8 February 2018

**SECTION 96(1A) MODIFICATION APPLICATION TO SSD 7445
SITE 9, OLYMPIC BOULEVARD, SYDNEY OLYMPIC PARK (SSD 7445)**

Figure 4 – Proposed layout and extent of indicative north eastern façade change on the Ground Floor

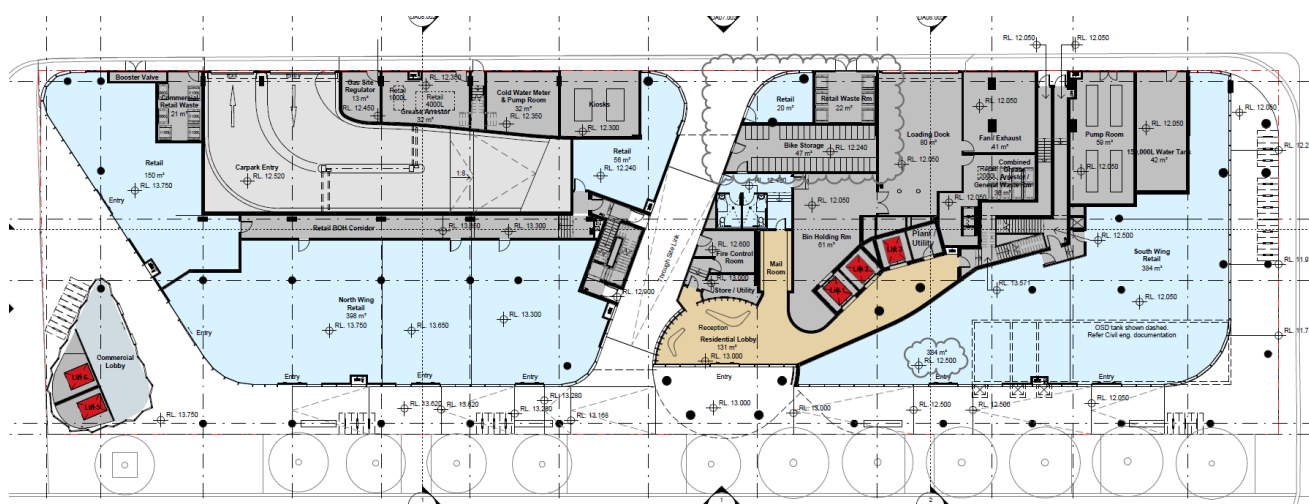
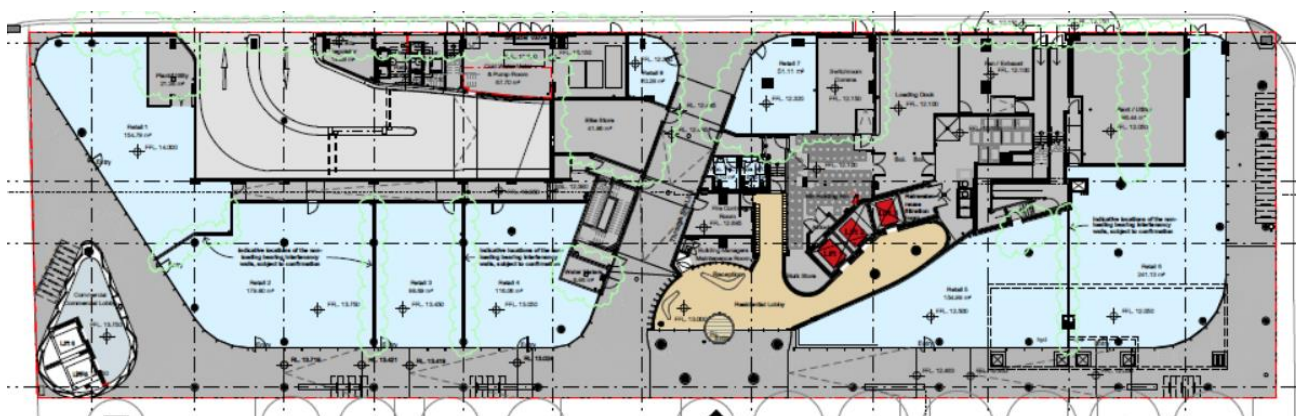
This application seeks to reconfigure the plant rooms to align with the preferable and optimal service requirements. The residential bike store has been relocated from the southern section of the ground floor (as demonstrated in **Figure 3**) to the northern section of the ground floor (as demonstrated in **Figure 4**). The locations of the retail intertenancy walls on the ground floor are subject to confirmation (as shown in **Figure 4**).

Figure 5 – Approved location of amenities on level 03

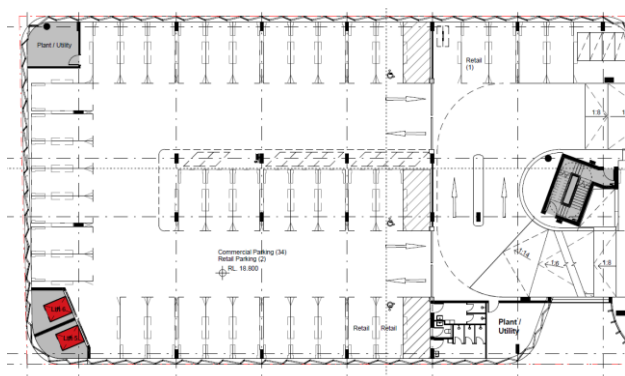
The commercial amenities on Level 03 have been relocated from the western wall as included in **Figure 5** to the eastern wall as included in **Figure 6**.

Figure 8 – Proposed location of the new plant room on the roof of level 09

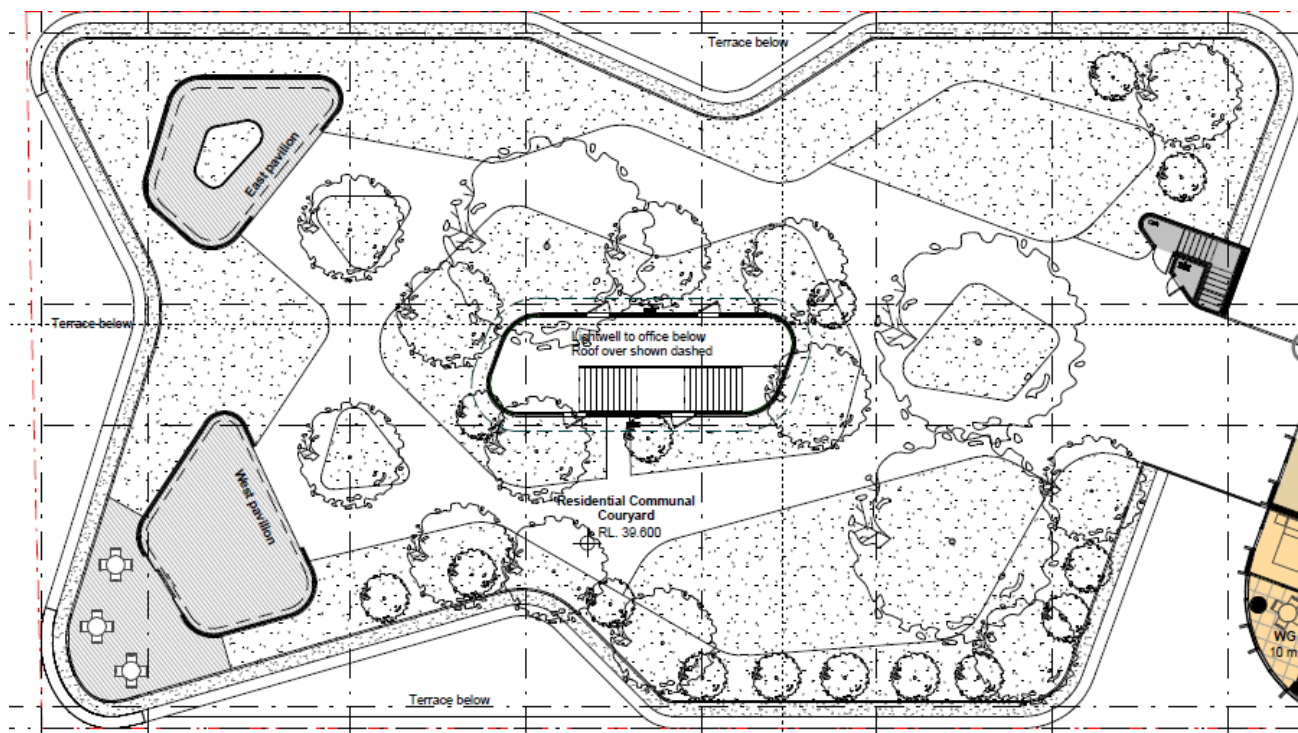
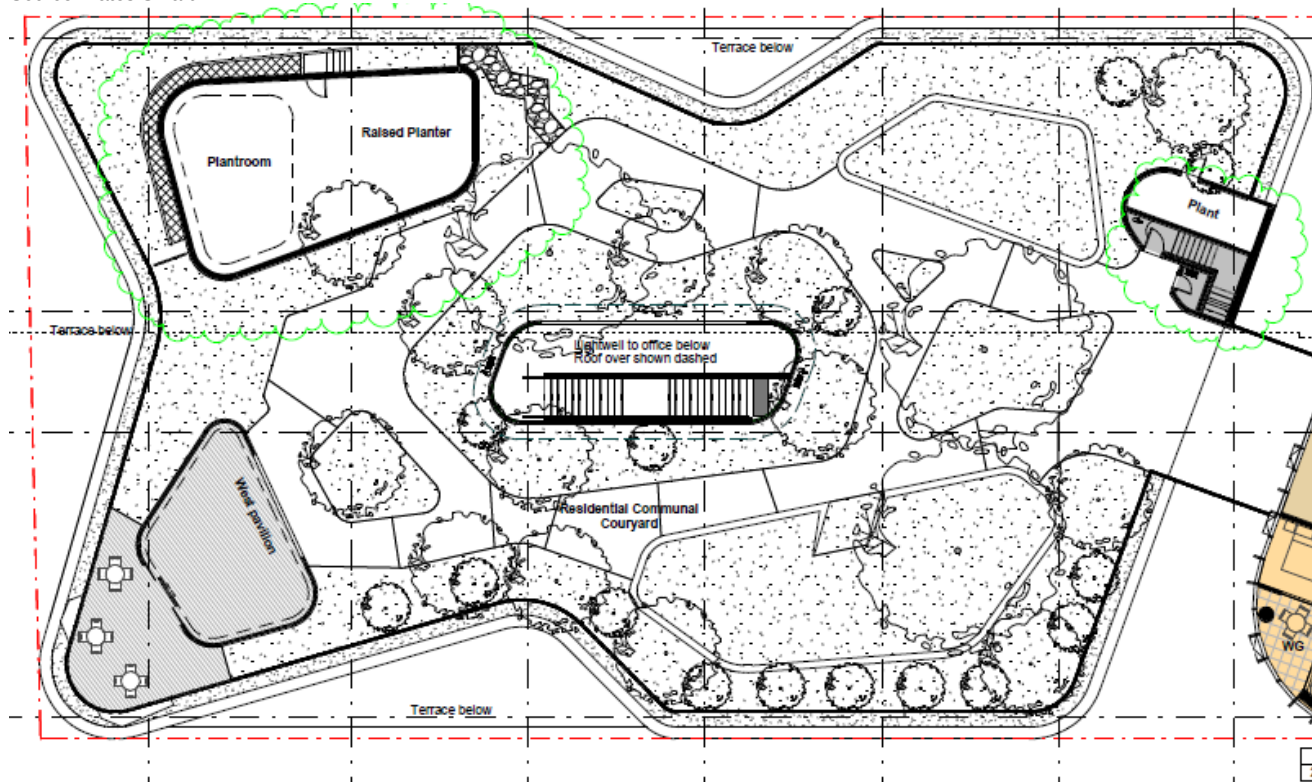
The reconfiguration of the communal roof top includes deleting the eastern pavilion (shown in **Figure 7**), two new plant rooms, minor modifications to the benches and landscaping (shown in **Figure 8** and **9**). In addition, the application is seeking to modify the proximity to railway plan to amend the RL 42.8 of the northern roof to be consistent with the approved RL of 42.6 northern roof of the podium and amend RL 39.6 of the parapet north to be consistent with the approved RL of 39.42.

Figure 10 Proposed open aluminium louvres to the plant room on Level 09

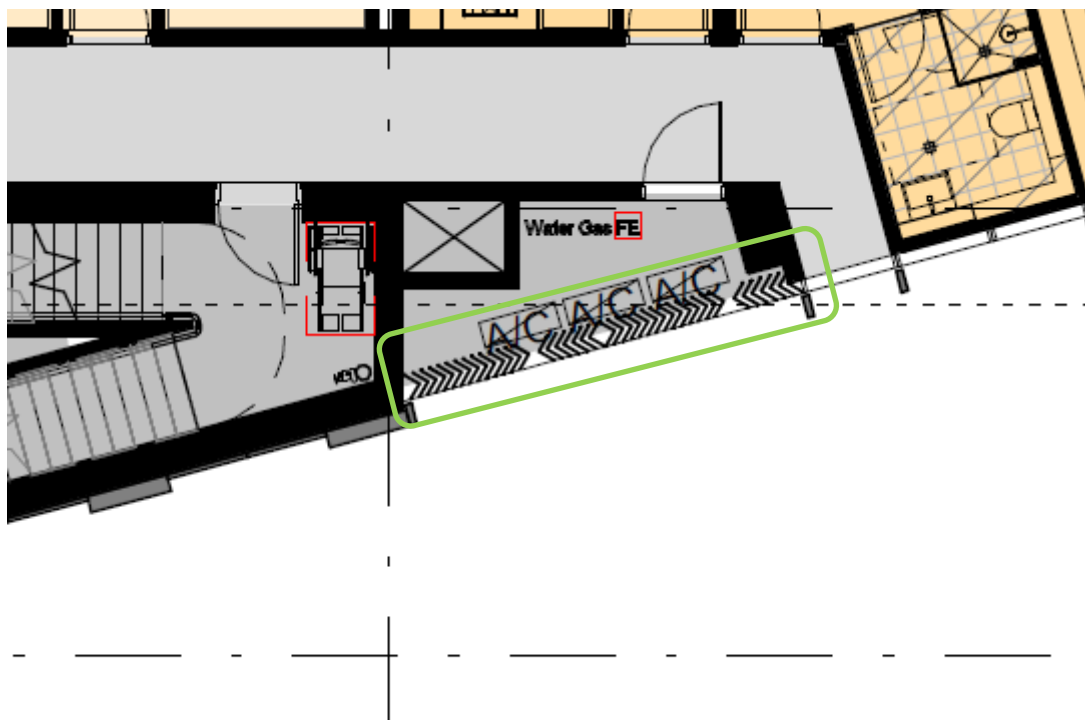
Clarification of the extent of the louvres on the façade to be consistent with the approved facade (shown in **Figure 15**) and indicative finish/material of the north eastern façade (shown in **Figure 16**). The louvres for the air conditioning plant room on Levels 07 to 37 are proposed to be fixed open to allow for ventilation for the air conditioning plant as shown in **Figure 10** on the Level 9 floor plan. The proposed materials/finishes of the façade of the north eastern elevation of the ground floor are indicative, however the materials are expected to comprise of a combination of glass (shown as finish/material 3 on the schedule) and metal cladding/louvres (shown as finish/material 10 on the schedule).

Figure 11 – Approved plant on level 07

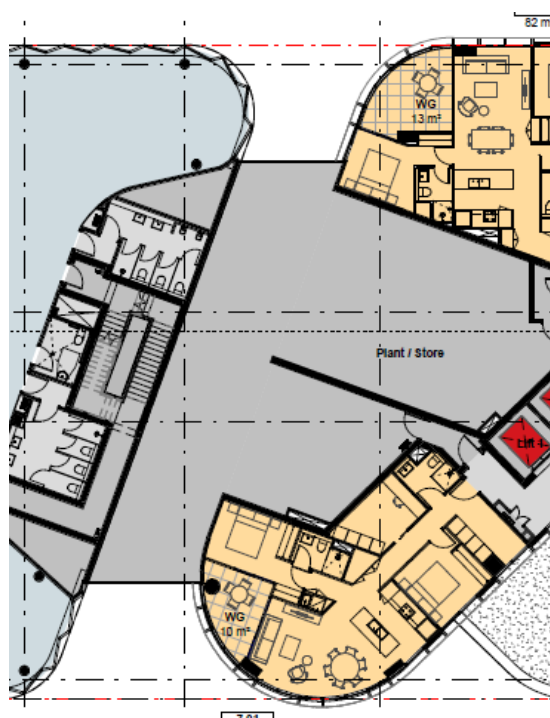
The façade treatment on Level 07 and 08 (shown in **Figure 11** and **13**) will be extended to screen the plant room (shown in **Figure 12** and **14**) to be consistent with the approved façade.

Figure 14 – Proposed amenities and screen to enclose plant and removal of louvres on level 08

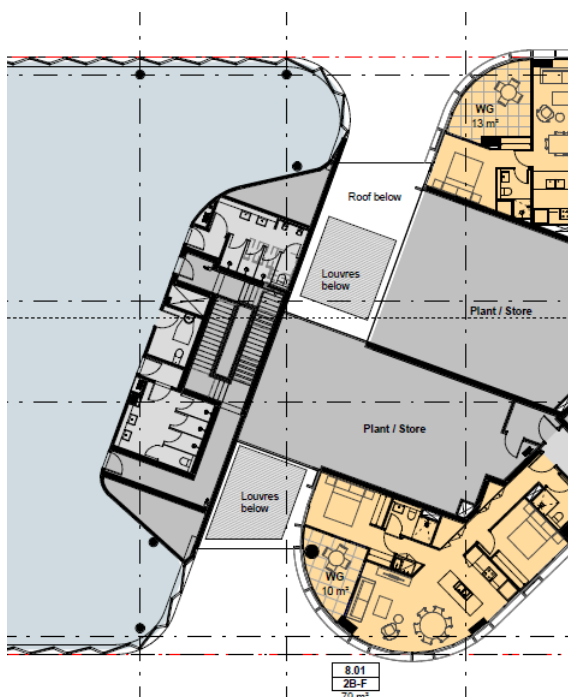
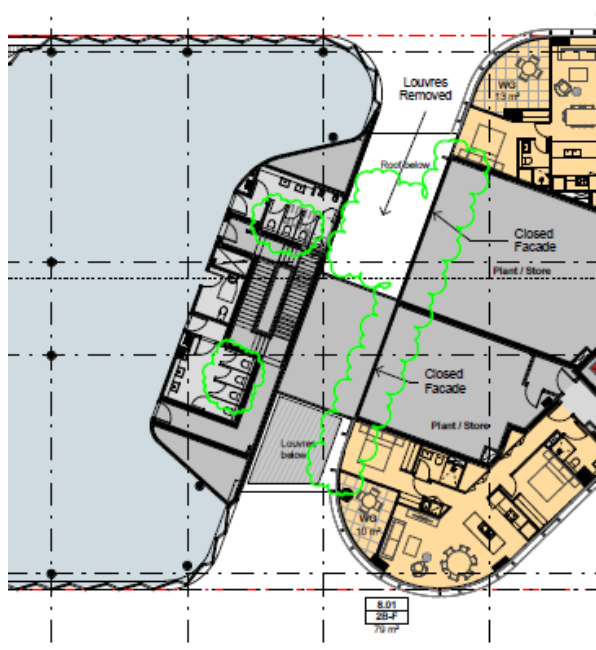
Six commercial showers have been deleted and replaced with toilets.

Figure 15 – Proposed fixed open aluminium louvres to the plant room on Levels 7 to 37 on the south west elevation

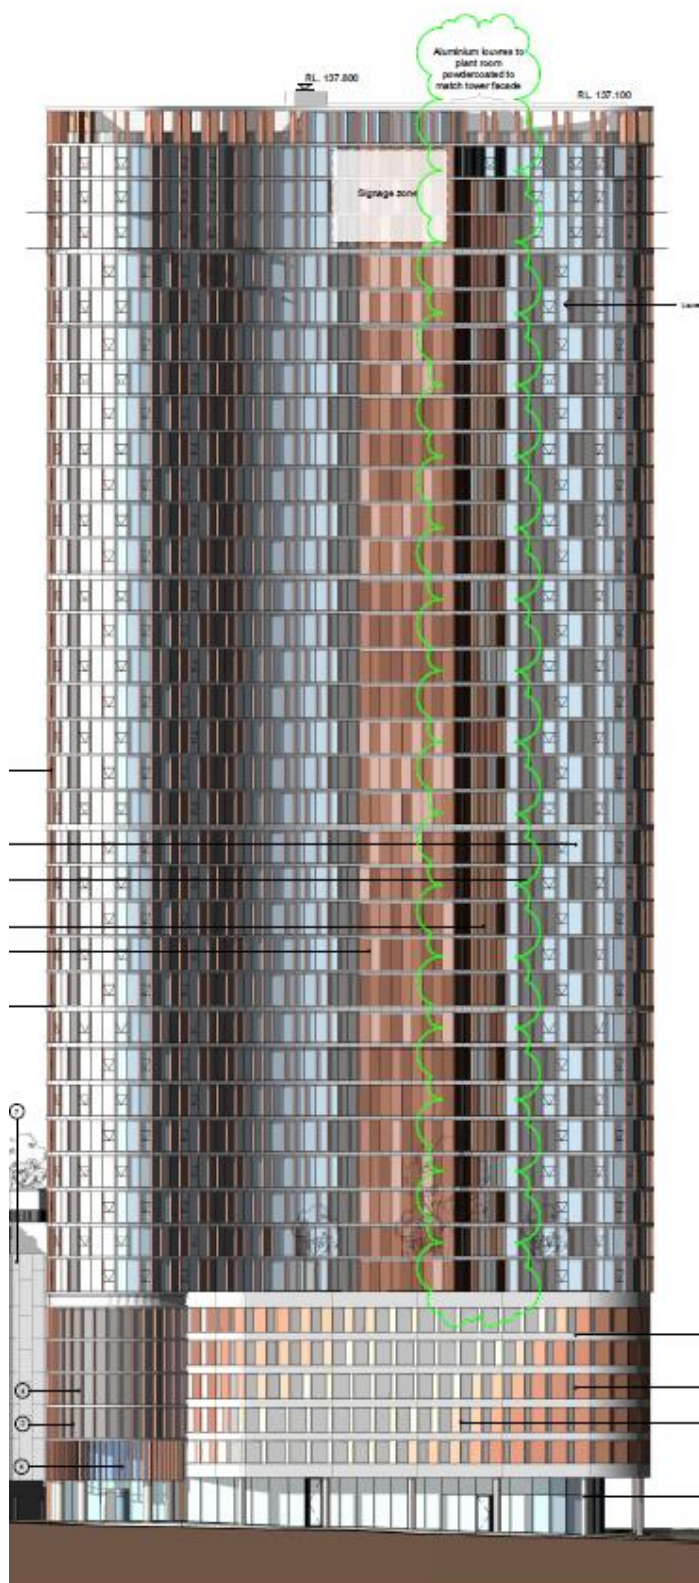
The proposed modifications are generally within the approved building envelope with a minor change to delete the eastern pavilion, new plant rooms on Level 09 and additional louvres. The minor modifications to the façade are to screen the plant by enclosing façade of the plant rooms on Level 07 and 08. The proposed continuation of the facade will be integrated into the approved design by matching with the approved façade (as shown in **Figure 15**).

Figure 18 – Proposed Services on level 39 and extension of the roof

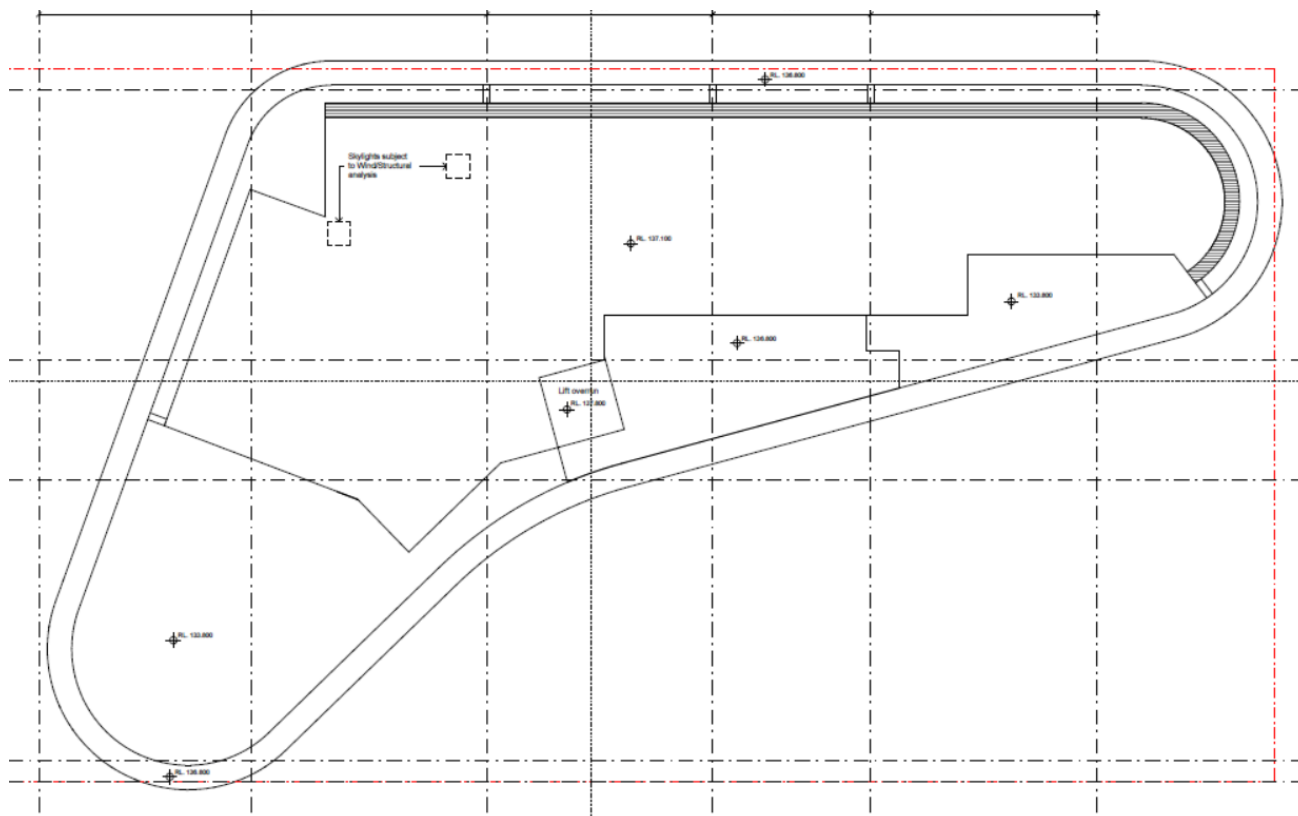
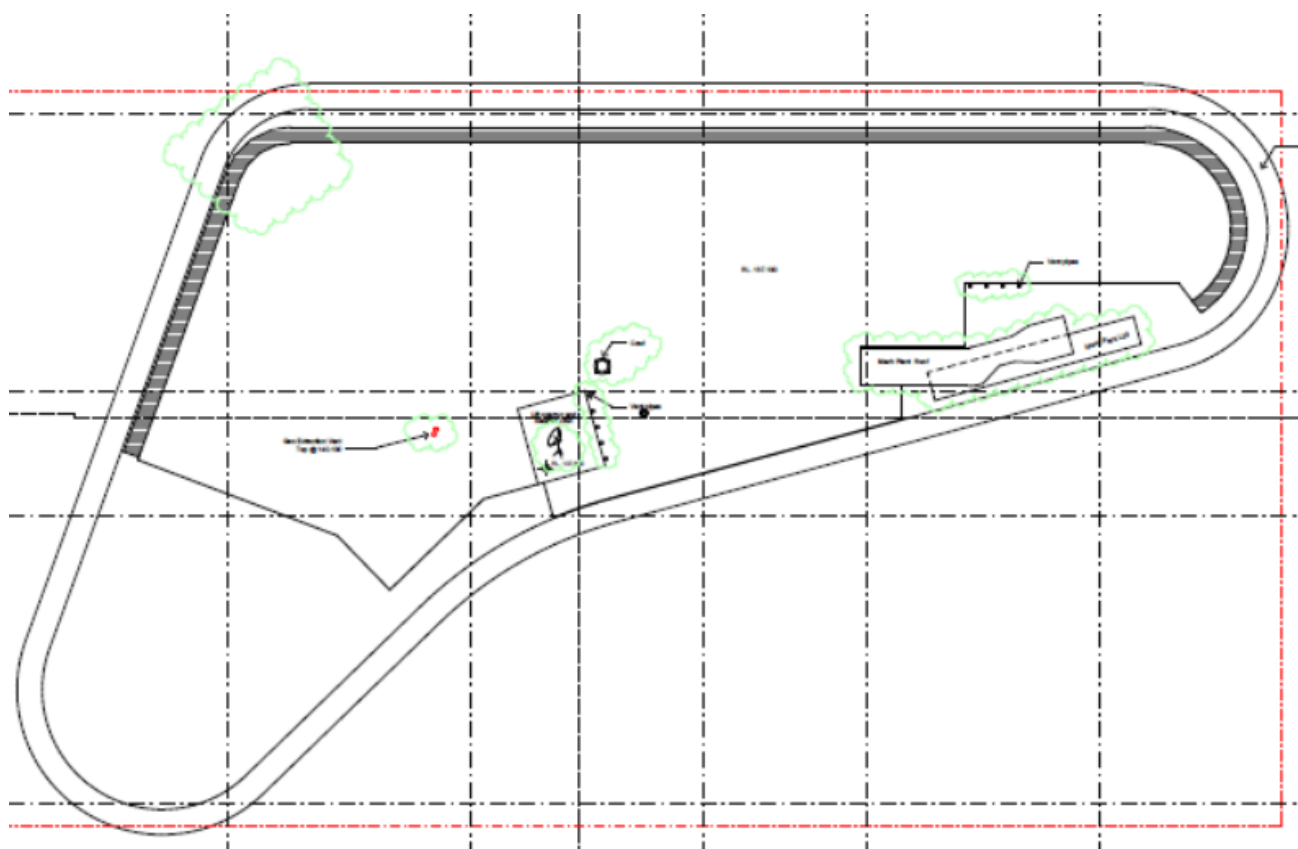
The proposal includes reconfiguration of the approved services on the roof and on level 39 (shown **Figure 17**), the reconfiguration of plant on level 39 consists of mechanical plant and the reconfiguration of the plant on the roof consists of vent pipes and mechanical equipment (shown in **Figure 18**).

The proposed modifications include a minor extension to the roof of the penthouse on Level 39 (shown in **Figure 17**) to cover the northern part of the balcony garden (shown in **Figure 18**). The minor extension to the roof is in keeping with the approved roof alignment and the setback is consistent with the approved roof, which is setback from the building edge. The approved parapet includes fins around the penthouse on Level 39 to assist in the parapet reading as an architectural feature rather a continuation of the building. We note that extending the roof form will not impact on satisfying Condition B2 (provided below). The minor extension to the roof form will not give rise to any changes to the visual presentation of the building noting that the level 39 parapet screens the penthouse and proposed roof extension.

Figure 20 – Proposed Plant Room and Raised Planter on Roof Level 09

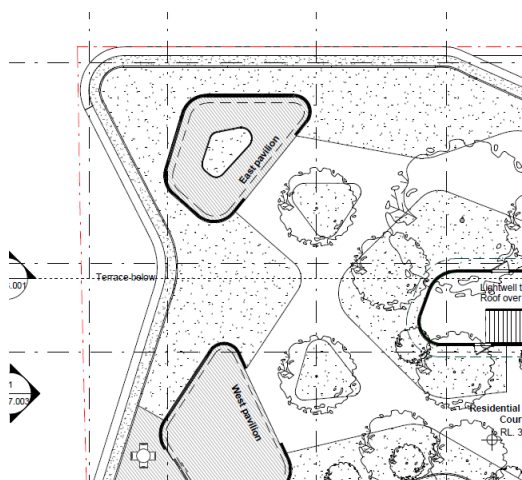
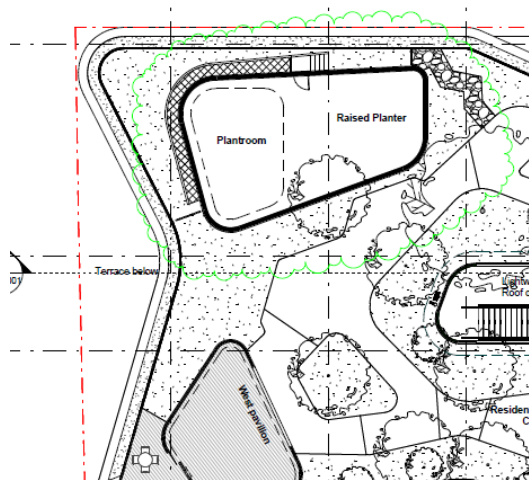
The proposed modifications include the relocation of the commercial building plant specifically the mechanical equipment from the plantroom on level 07 and 08 to the roof of level 09. The approved location in the plantroom on level 08 would discharge exhaust air vertically into the podium level (level 09) above. Renzo and Associates have prepared an acoustic statement in support of the relocation of the plant from level 08 to the roof of level 09 (provided in **Attachment F**). The plantroom discharge openings are located 2m to 3m from the nearest apartments, (above and beside), that could impact on the amenity of the apartments should the design not be modified as proposed.

Furthermore, the apartment balconies on level 09 and adjacent level 07 and 08 that overlook the plant room could be adversely impacted by the mechanical plant noise, heating and cooling, due to the proximity of the discharge openings and the total number of condensers in the plant room. The approved location of the mechanical plant (shown in **Figures 8, 11 and 13**) would require the extension of the acoustic treatment to the individual condensers. In addition to the extensive acoustic treatment to the plant room, the efficiency of the plant could potentially be impeded. The proposed modifications include deleting the eastern pavilion on the roof of Level 9 (shown in **Figure 7**) to accommodate the new plant room (shown in **Figures 8 and 9**), which will be located approximately 45m from
